Preferred Alternative Updates for Public Comment

March 30, 2021

Since publication of the I-69 Ohio River Crossing (ORX) Draft Environmental Impact Statement (DEIS) in December 2018 and the January 2019 public hearings that followed, the Indiana Department of Transportation (INDOT) and the Kentucky Transportation Cabinet (KYTC) have been reviewing comments received on the DEIS and further evaluating the project's design. The purpose of this document is to provide:

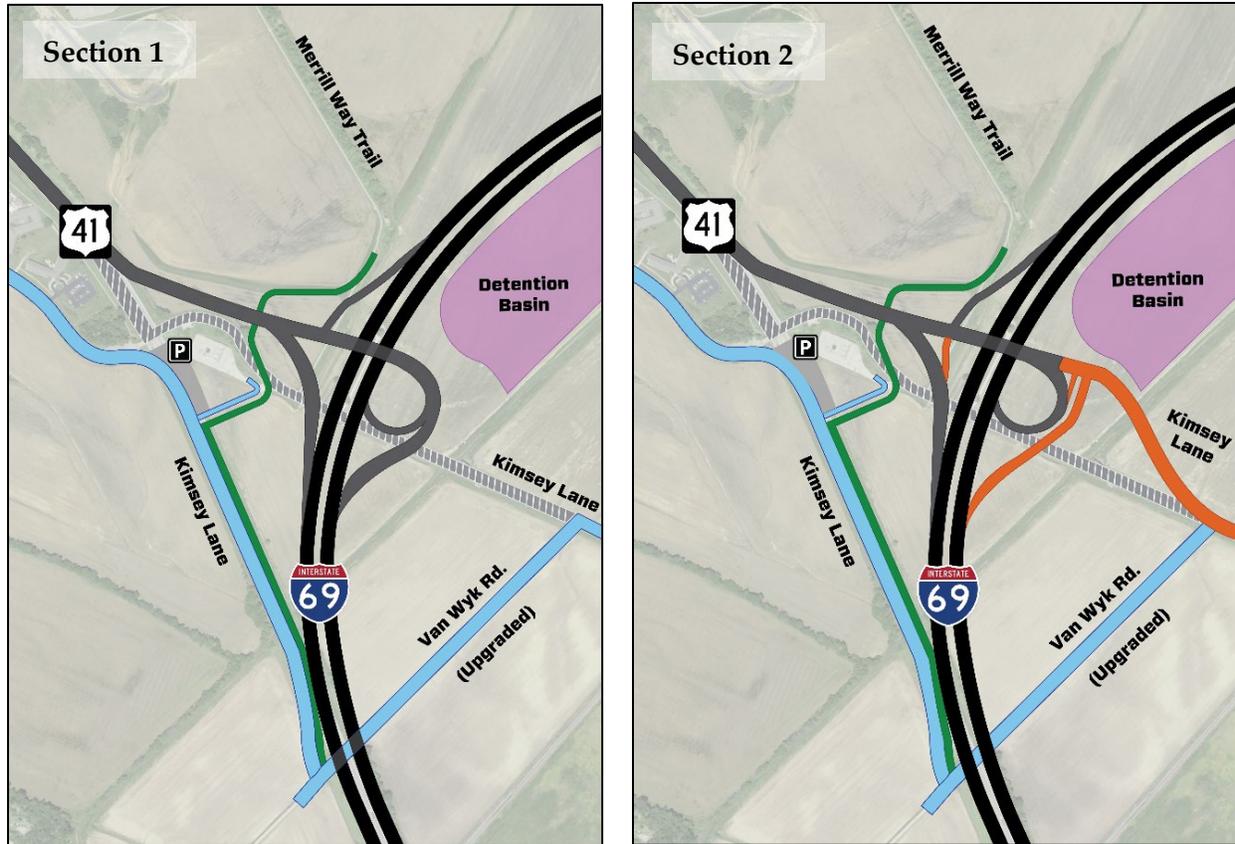
- US 60 Interchange: As shown in the figure below, the modified design at this interchange improves the connection of Tillman-Bethel Road to the relocated US 60. To the west of I-69, the US 60 alignment was modified to avoid impacts to a cemetery.
